NOTICE IS HEREBY GIVEN THAT THE CENTERVILLE CITY PLANNING COMMISSION WILL HOLD ITS REGULAR PUBLIC MEETING AT 7:00 P.M. ON WEDNESDAY, DECEMBER 10, 2014, AT THE CENTERVILLE CITY COMMUNITY CENTER AND CITY HALL COUNCIL CHAMBERS, 250 NORTH MAIN STREET, CENTERVILLE, UTAH. THE AGENDA IS SHOWN BELOW.

PLANNING COMMISSION MINUTES OF MEETING

PROPERTY OWNER/ APPLICANT:	ROBERT HOLMES CONSTRUCTION INC. 683 WEST 910 NORTH WEST BOUNTIFUL, UT 84087
PROPERTY:	1384 WEST 75 NORTH
ACREAGE:	.70 ACRES
ZONING:	INDUSTRIAL-HIGH (I-H)
APPLICATION:	CONCEPTUAL SITE PLAN ACCEPTANCE FOR PARKINS OFFICE/WAREHOUSE
USE:	OFFICE/WAREHOUSE
RECOMMENDATION:	ACCEPT THE CONCEPTUAL SITE PLAN

PORTER WALTON SENIOR LIVING COMMUNITY

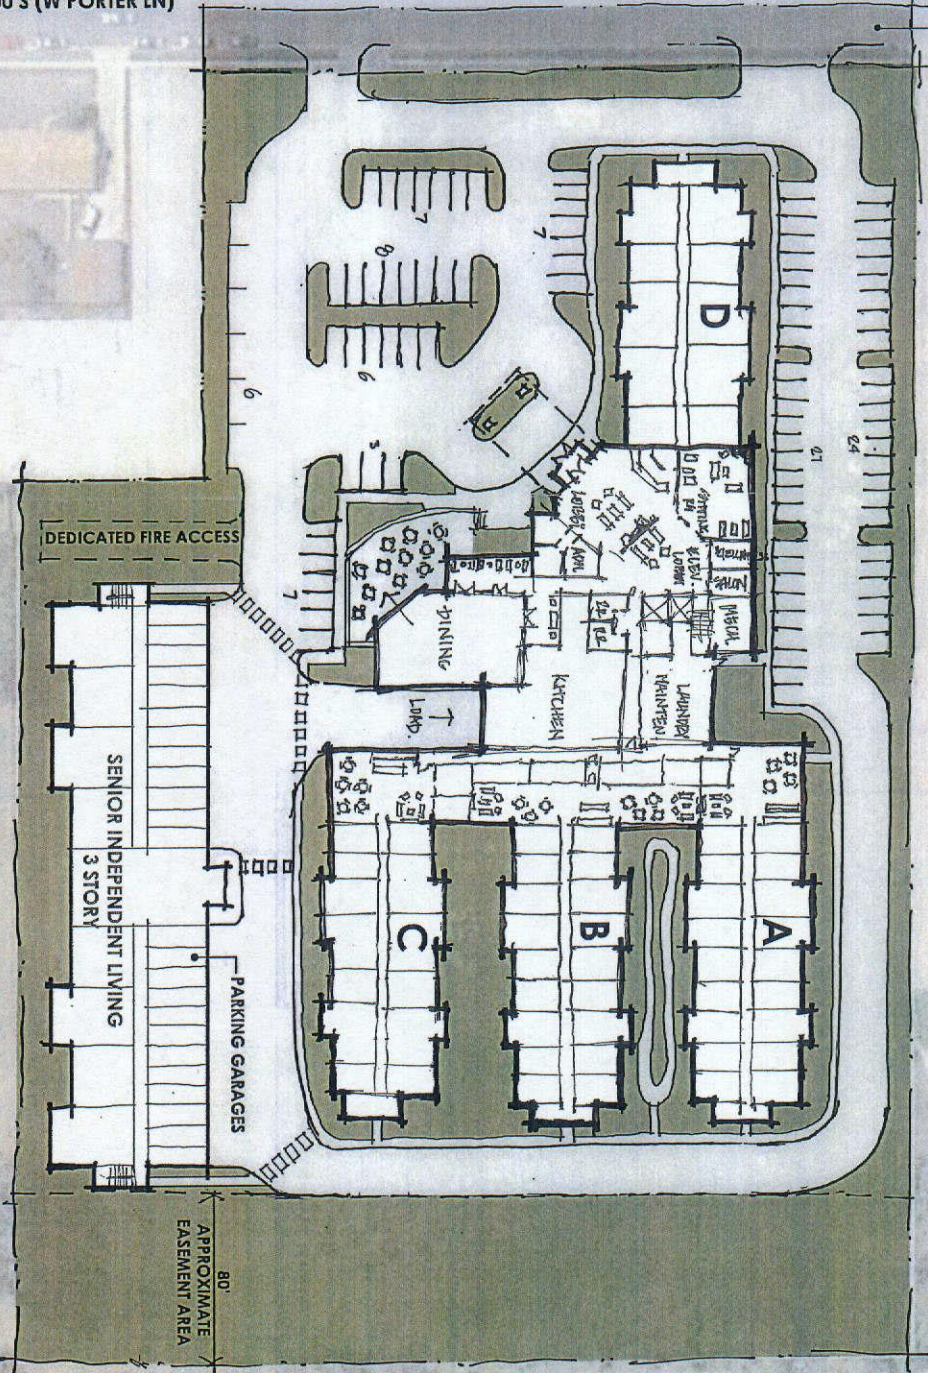
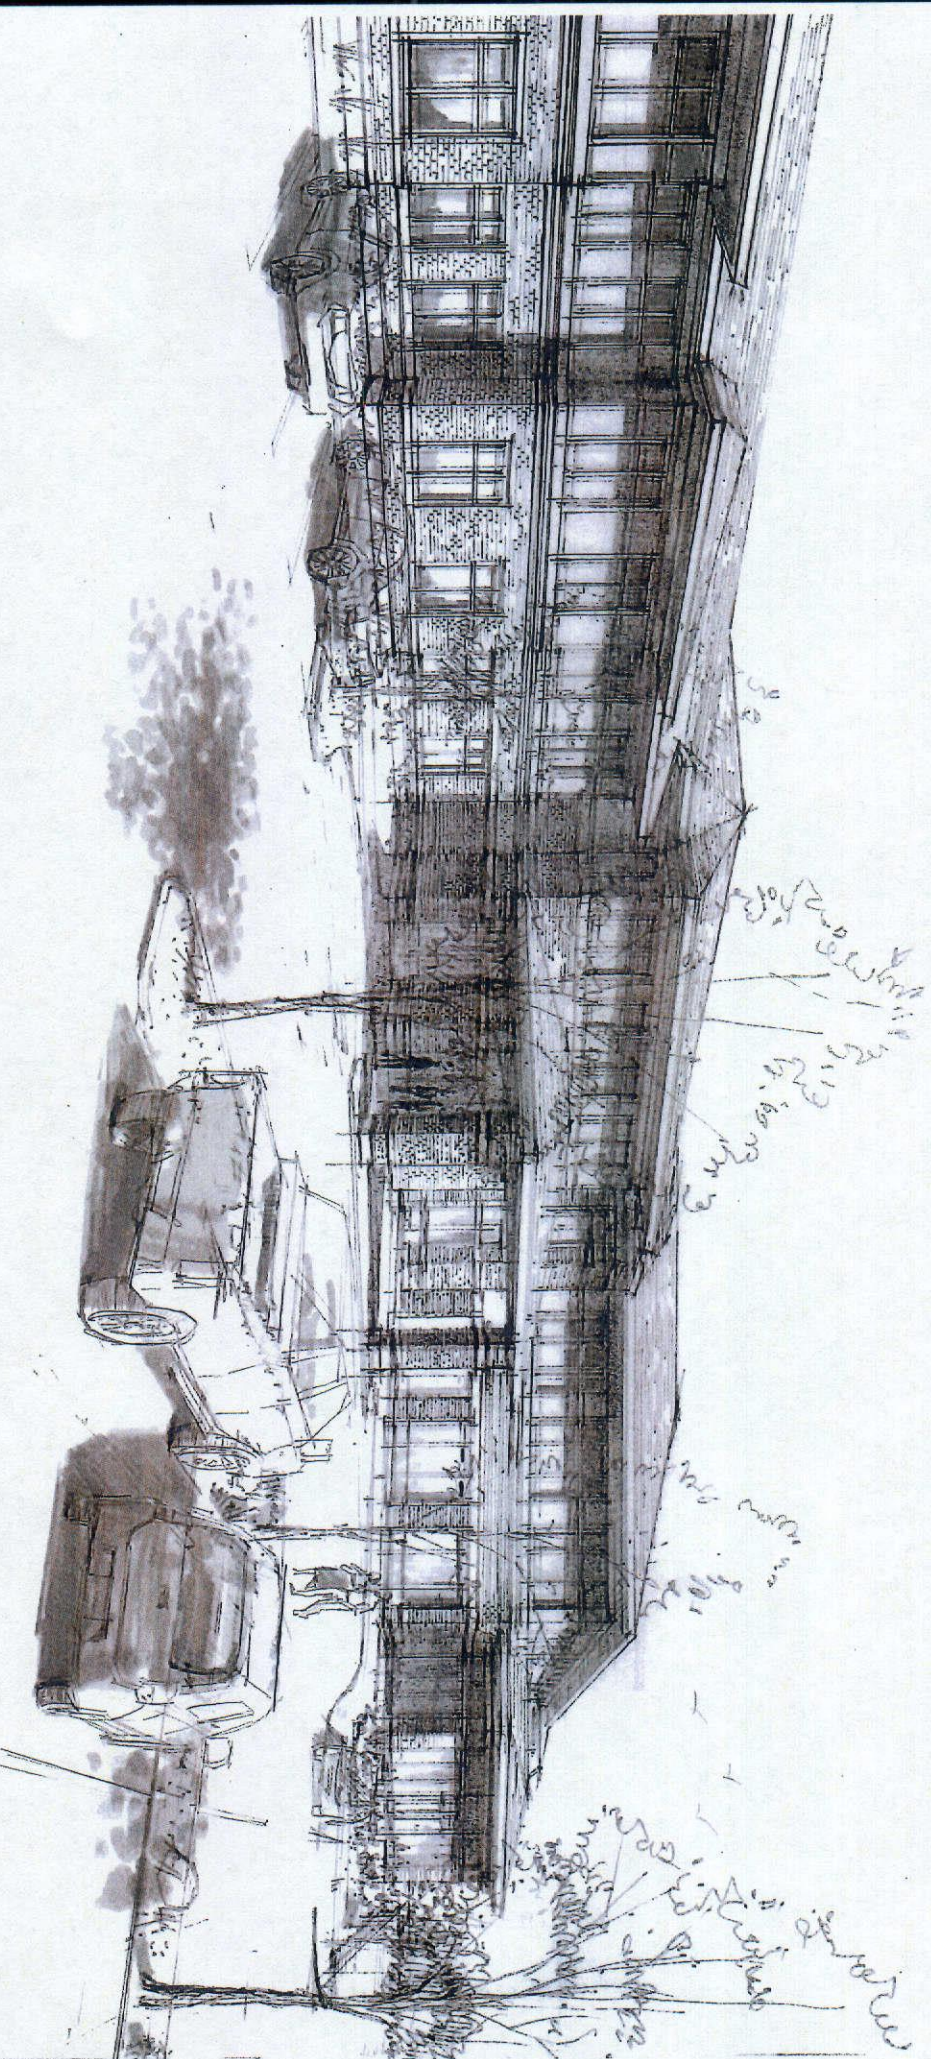
Use	Standard	Provided	Compliance
Assisted Living Use	1 space per 5 beds & 1 space per employee (highest shift)	89 Stalls (Employees = ?)	Uncertain
Multi-family	1.5 spaces per studio or 1 bed, or 2 spaces per 2bed+	54 or 64 (plans not clear)	Uncertain
Total		153 Parking Stalls (?)	Uncertain

Since there are two different parking calculations and the submitted plans are not clear, the parking issue is in need of further evaluation. The applicant has previously indicated to staff that

The submitted plans indicate the general location of landscaping, however, no detail is given. Since the property is greater than one acre, it will require a landscape architect prepare a landscaping design for the final site plan application submittal. These plans must indicate location of all landscaping, types of plantings, total number of plantings and accurate calculations of landscaping percentages and totals.

The plans do not show any detail concerning the trash enclosures. The final plans will need to provide details indicating the number of dumpsters to be provided. Also, all dumpsters must be completely screened from view with an opaque six-foot wall or fence. The wall or fence must be compatible in material and color of the main buildings on the site. In addition to the dumpster, any wall or roof-mounted equipment will need to be screened from view of the public street.

- Fire Access, Circulation, and Protection (see Section 12-21-100.e.5.g & h) - The final plans need to be reviewed by the South Davis Metro Fire Agency and the Public Works Director to ensure that there is capacity for staffing, access and circulation, and hydrants; including fire hydrant flow capacity to service the proposed uses.

- Utility and Drainage Capability & Capacity (see Section 12-21-100.e.5.g & h) – Such facilities are located in the area of the development. However, the location of the sewer line (south side of Porter Lane) may create problems with engineering the needed utilities. Additionally, the site appears to slope northward and the drainage facilities available to tie into are in a different storm drainage zone. This will need to be addressed with the City Engineer to determine how to provide for proper site drainage and storm water management.

- Open Space and Pedestrian Circulation Needs (see Section 12-21-100.e.5.h) – By creating a place of differing housing needs, specifically for the aging population, staff sees the need to provide outdoor open and/or covered spaces for residents and relatives to gather and socialize. This is particularly needful with persons residing in the independent living units and the ambulatory patients of the assisted living facility. There are no publicly provided outdoor spaces nearby, thus the final plans ought to address providing such quality of life amenities for residents, specifically for those with some restricted mobility. Although the plans do depict an outdoor seating area near the dining facility, the plan lacks providing small play areas or passive spaces for more intimate opportunities for multiple families visiting the residents of the project. A pedestrian circulation element also needs to be provided in the design plan to comprehensively connect such areas.

- Buffering, Screening and Lighting (see Section 12-21-100.e.5.h) – The planning staff believes that there are three areas to consider. First, is the landscaping depth along Porter

Lane. Typically, with a residential building, the setback of 25 feet is maintained in landscaping. Due to any internal driveway lane, the plans depict only 15.5 feet. Staff believes that this should be further mitigated using more than just turf-style planting. Additional features, such as short walls and fencing, landscape berming, and other elements would provide needed buffering in exchange for a reduction in typical turf area. Second, since the adjacent lot is undeveloped, the parking lot area to the west needs to be buffered to mitigate any future visual impacts from multiple cars and headlights. Third, the multi-family building (*i.e. independent living units*) is located fairly close (meets setback however) to the adjacent property. Even though the adjacent lot is currently a private sports field, this could change in the future and such a large building with little to no buffering would be an imposing element for any redevelopment of the sports field.

PROPOSED ACTION: I hereby make a motion for the Planning Commission to accept the conceptual site plan for the Porter-Walton Senior Living Community, to be located in the area of 564 West Porter Lane, with the following directives:

1. The applicant must submit a final site plan application meeting the standards found in Section 12-21-110(e) of the Zoning Ordinance.
2. The applicant must submit a conditional use permit application to consider allowing for an assisted living facility and multi-family density of 8 units per acre, as described in the December 10, 2014 Planning Staff Report, which must address the standards found in Section 12-21-100(e) of the Zoning Ordinance.

3. The conditional use application submittal shall also address the anticipated issues and concerns, as outlined in the December 10, 2014 Planning Staff Report.

4. A Landscaping Plan, prepared by a Landscape Architect, must be submitted to address the standards of Chapter 12-51-Landscaping & Screening, as also outlined in the December 10, 2014 Planning Staff Report.

5. A site sign package must be submitted for review by the Planning Commission and the Zoning Administrator in accordance with Chapter 12-54-Signs.
